6 Chaomans Letchworth
Job No. **188** Elevations North AA
as proposed

Stage: Stage 3
Status: **Non-material amendment**

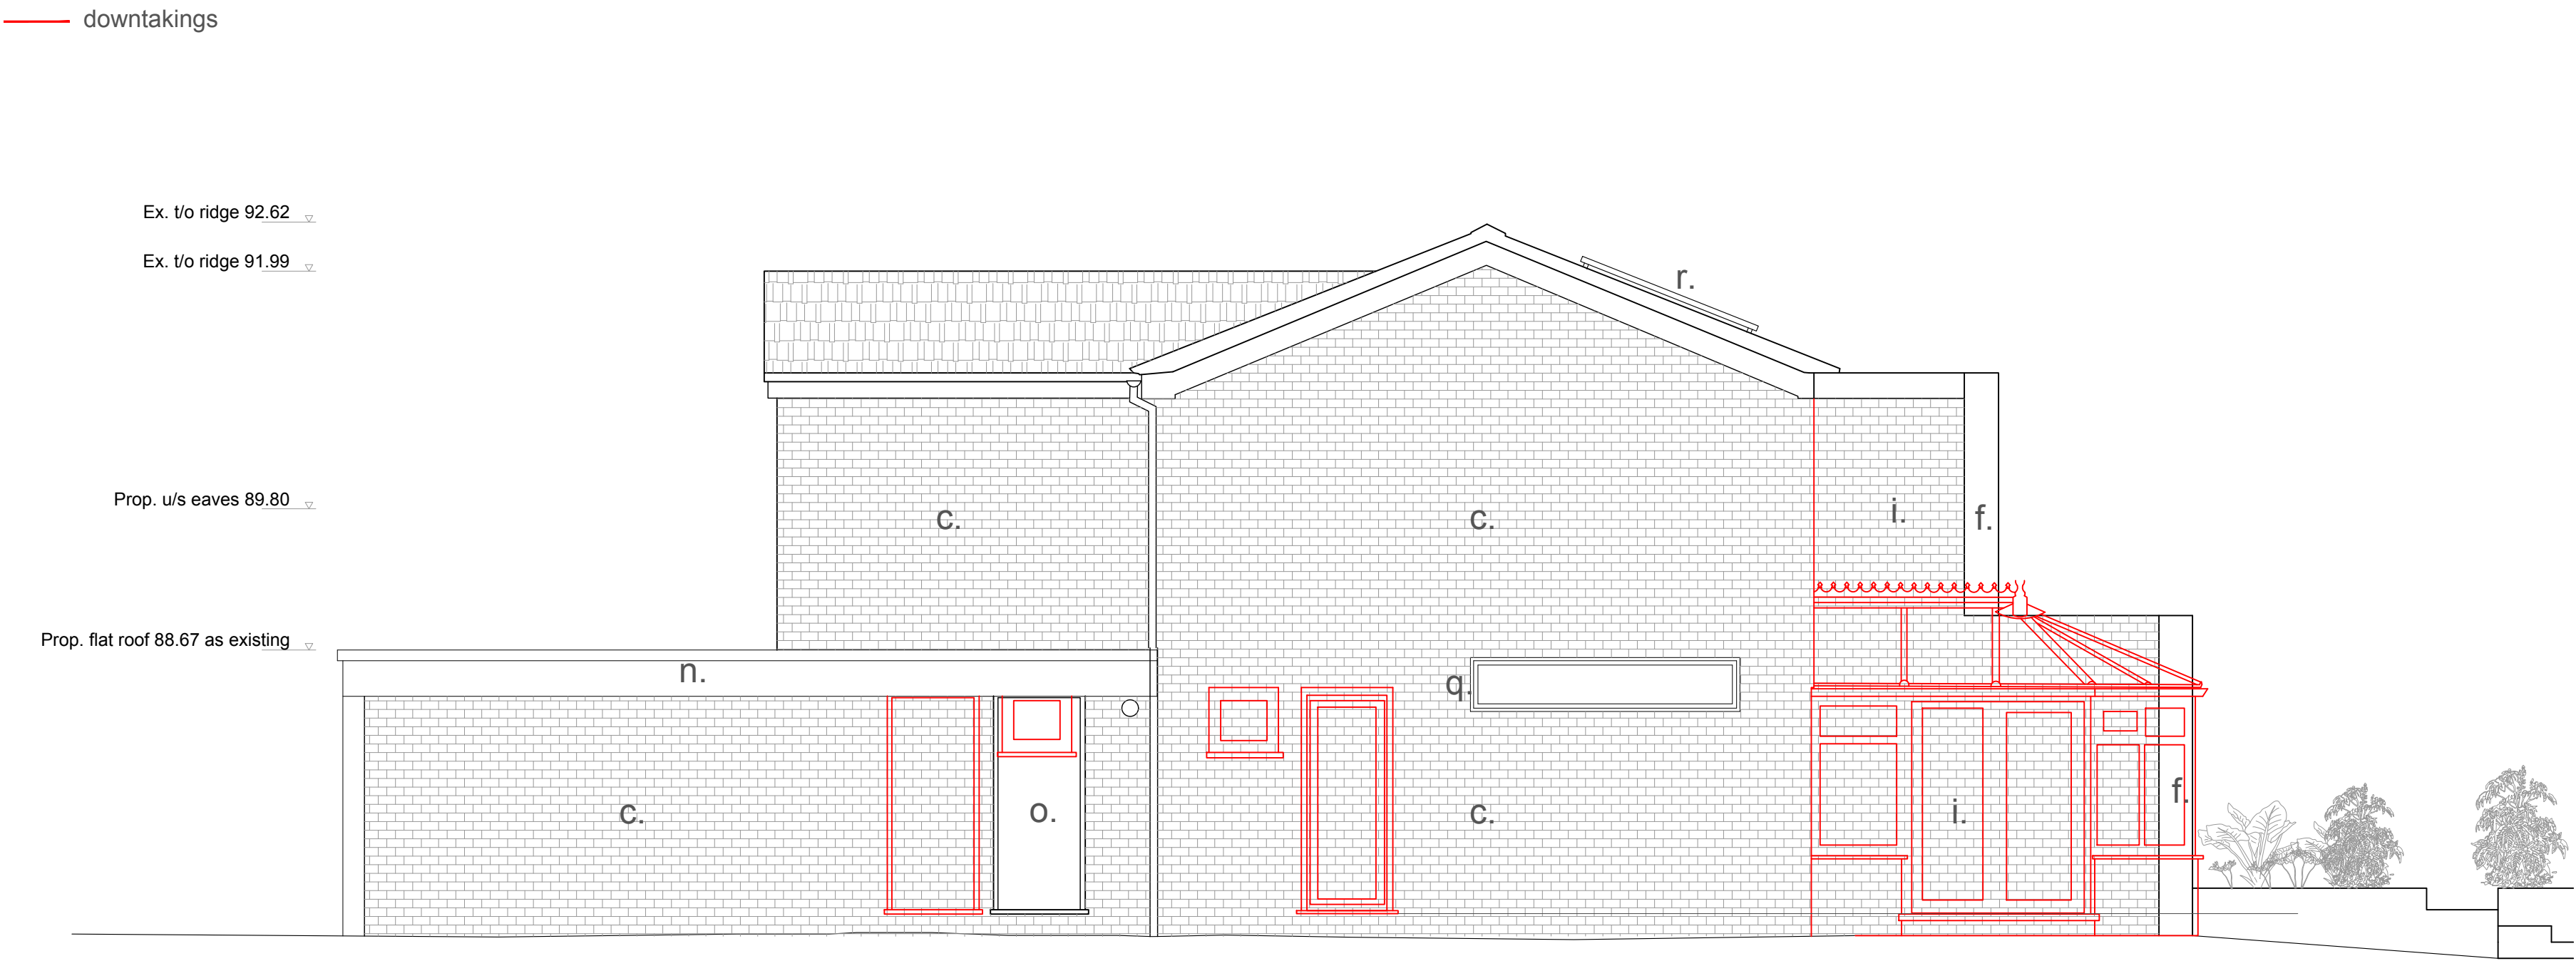
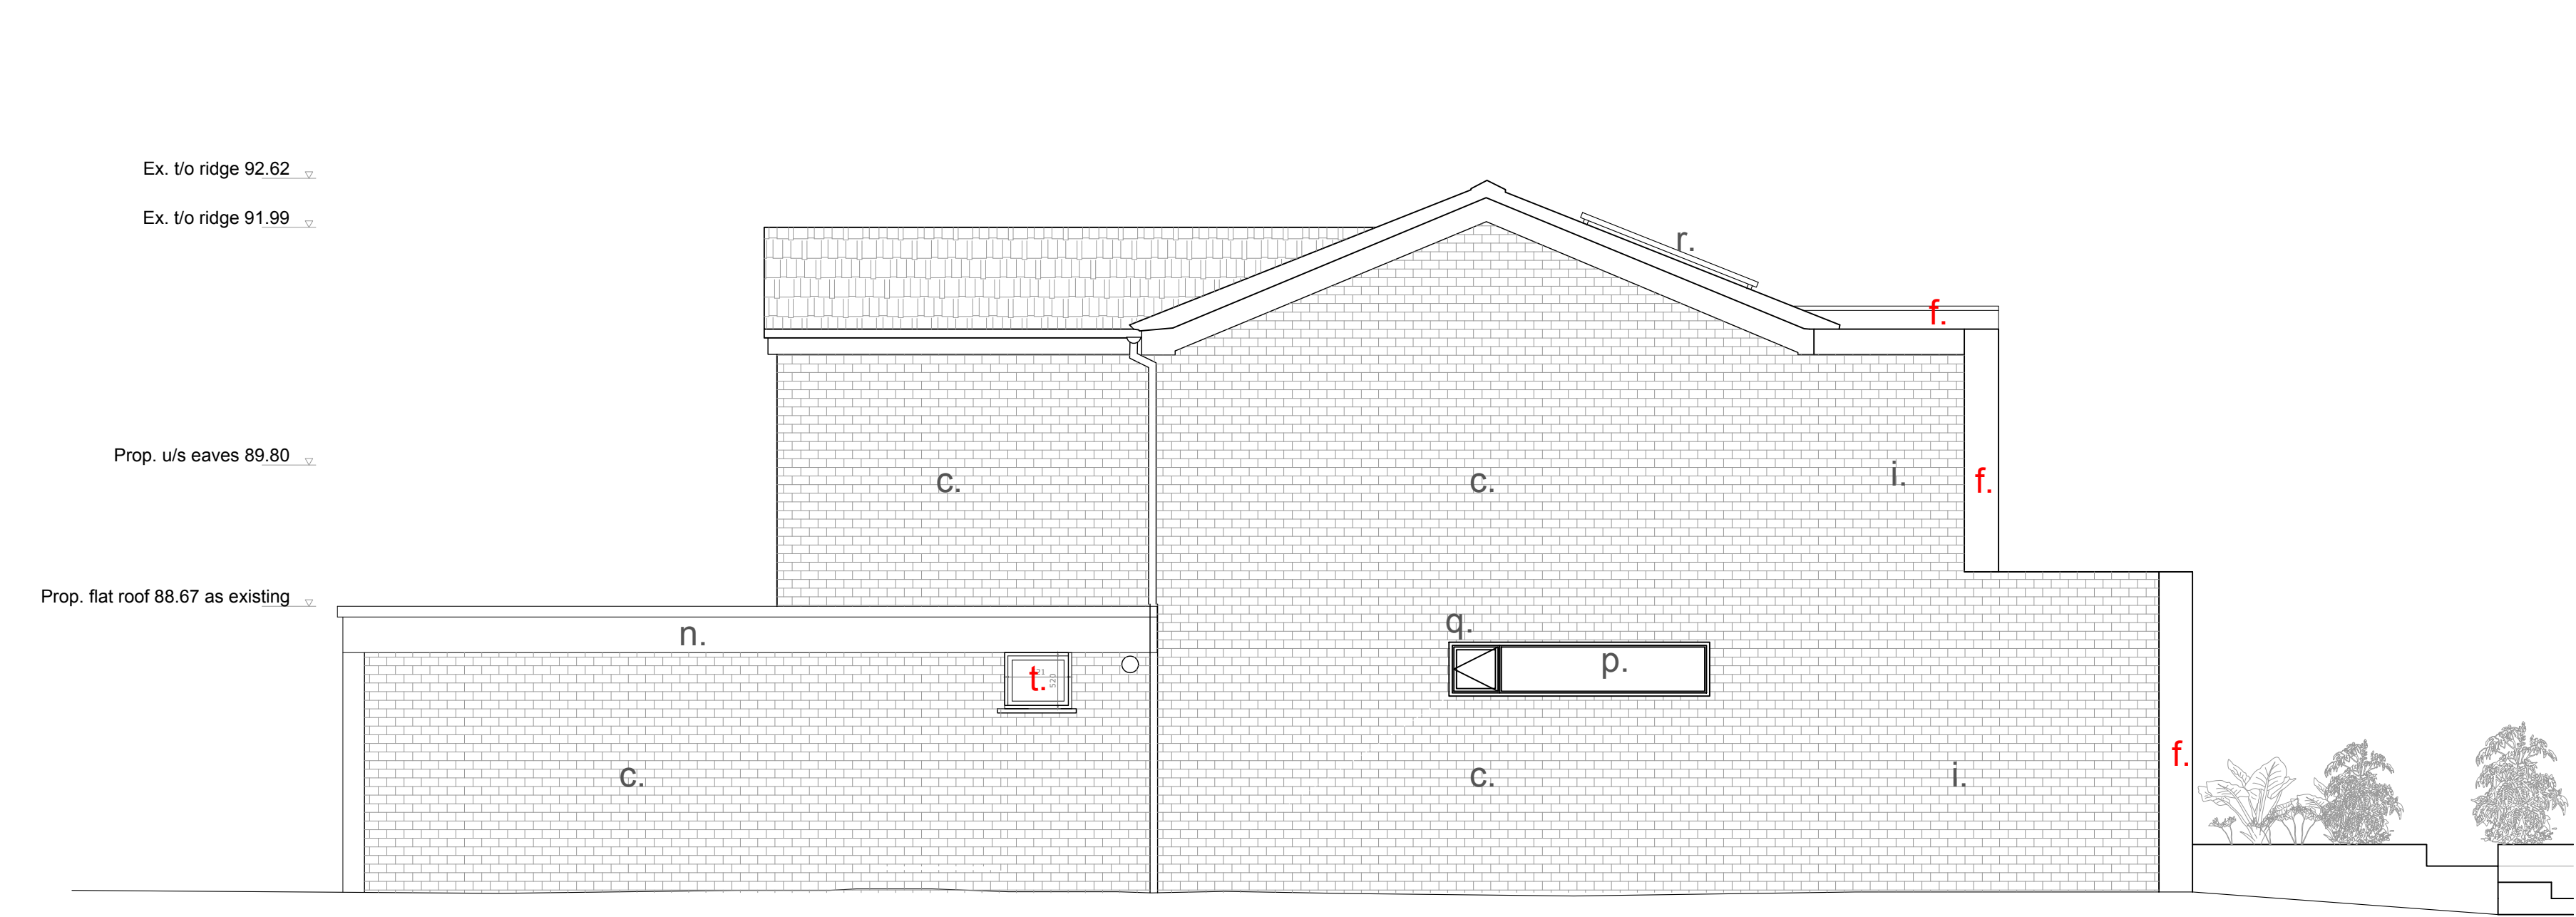
- a. Replace white UPVC existing windows with **aluminium** window - white
- b. New timber front porch door with fixed glazing panel
- c. Existing brick wall
- e. New rooflight
- f. New aluminium RAL 7013 cladding frame**
- g. New **iroko** timber cladding and louvered screen
- h. Existing side gate
- i. New brick wall to match existing
- j. New slimline aluminium sliding doors bronze anodised
- k. New flat roof
- l. Widflower flat roof
- m. Aluminium flashing **RAL 7013**
- n. White fascia
- o. New door - wood
- p. New slimline aluminium windows **RAL 7013**
- q. Oak frame for window
- r. New PV panels
- s. New **white aluminium** window white to match the adjacent windows (**frosted glazing**)
- t. Replace existing UPVC windows with aluminium window RAL 7013**
- u. Seamless glazed balustrade**
